DELEGATED APPLICATION REPORT - Application No.: 190761/FUL

Address: 384 The Meadway, Tilehurst

Proposal: New Church and community centre

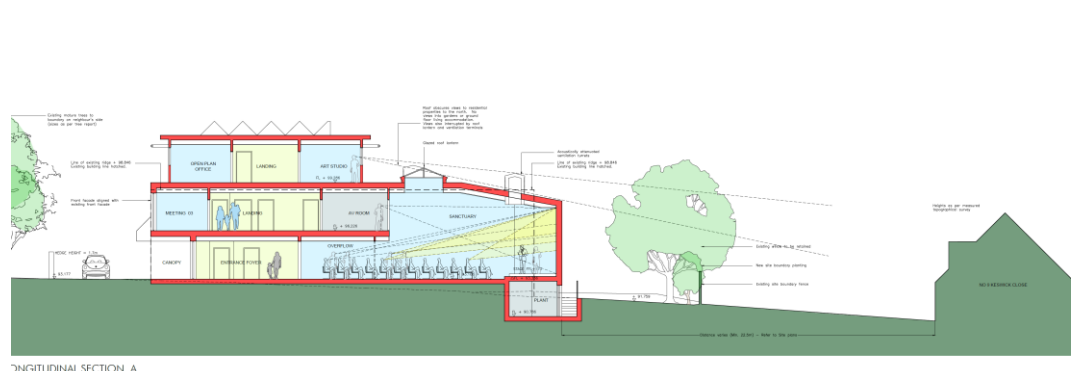
Officers agree with the concerns from objectors regarding overlooking with the original design and in the amended plans, a number of windows have been amended to be obscure glazed as specifically labelled on the plans. At the ground floor boundary fence heights, and existing and proposed boundary planting will protect privacy to the neighbouring properties. In any case the ground floor doors serving the rear exits are proposed to be obscure glazed.

A number of first floor side facing windows are proposed to be obscure glazed. The Case Officer also raised the issue of potential overlooking from some of the meeting rooms through the double height worship space windows via the internal glazed screens of the rooms. A plan was submitted (no: 255) which demonstrates that only oblique views would occur into the corners of 5A Keswick Close's garden, and would not be of the main rear elevation of the property, its living rooms or any of its windows. It is considered that other properties are at such a distance as there would be no loss of privacy, and existing trees and new planting provide good screening.
